TECHNICAL INFORMATION

SUBJECT: Guide bar stud on **ECHO CS-260T, CS-260TES, CS-270WES, CS-280T, CS-280TES, CS-281WES, CS-310ES, CS-353ES, shindaiwa 280TS, 280TCS and 305S**

Number: Y2014-552
Issued: Sep. 30, 2014

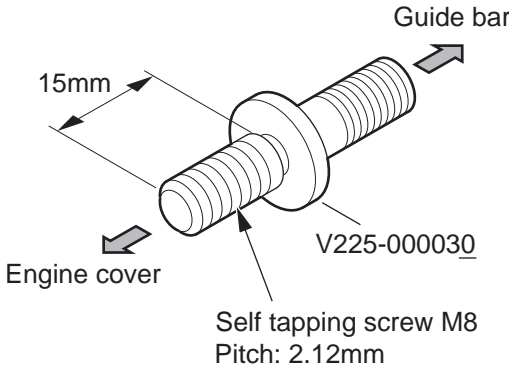
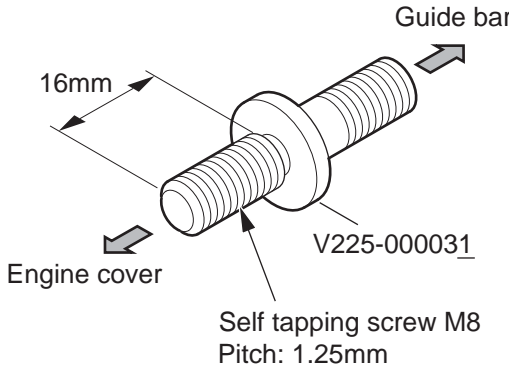
Changed guide bar stud screw pitch		
CS-260T (36)	Serial Number 36017239 and before	Serial Number 36017240 and after For spare parts
CS-260TES (20)	Serial Number 20007766 and after	Serial Number 20007765 and before For spare parts
CS-260TES (24)	Serial Number 24002150 and before Serial Number 24002581 and after	Serial Number 24002151 to 24002580 For spare parts
CS-260TES (30)	Serial Number 30009800 and before Serial Number 30012251 and after	Serial Number 30009801 to 30012250 For spare parts
CS-260TES (36)	Serial Number 36111947 and before	Serial Number 36111948 and after For spare parts
CS-270WES (30)	Serial Number 30003035 and before Serial Number 30003356 and after	Serial Number 30003036 to 30003355 For spare parts
CS-280T (37)	Serial Number 37002601 and after	Serial Number 37002600 and before For spare parts
CS-280TES (37)	Serial Number 37011806 and after	Serial Number 37011805 and before For spare parts

CS-281WES (37)	Serial Number 37002351 and after	Serial Number 37002350 and before For spare parts
CS-310ES (37)	Serial Number 37052320 and before Serial Number 37052421 and after	Serial Number 37052321 to 37052420 For spare parts
CS-310ES (20)	Serial Number 20002958 and before Serial Number 20003259 and after	Serial Number 20002959 to 20003258 For spare parts
CS-310ES (24)	Serial Number 24001500 and before Serial Number 24002001 and after	Serial Number 24001501 to 24002000 For spare parts
CS-353ES (20)	Serial Number 20001651 and after	Serial Number 20001650 and before For spare parts
CS-353ES (25)	Serial Number 25001631 and after	Serial Number 25001630 and before For spare parts
280TS (37)	Serial Number 37003551 and after	Serial Number 37003550 and before For spare parts
280TCS (37)	Serial Number 37001871 and after	Serial Number 37001870 and before For spare parts
305S (24)	Serial Number 24002140 and before Serial Number 24003121 and after	Serial Number 24002141 to 24003120 For spare parts

305S (37)	Serial Number 37005250 and before Serial Number 37006051 and after	Serial Number 37005251 to 37006050 For spare parts
Guide bar stud	 <p>Self tapping screw M8 Pitch: 2.12mm</p>	 <p>Self tapping screw M8 Pitch: 1.25mm</p>
<p>Guide bar stud V225-000031 only is supplied as spare parts. Guide bar stud V225-000030 can be replaced with V225-000031. When repairing, apply a drop of Loctite 242 or equivalent to engine cover side of Guide bar stud.</p>
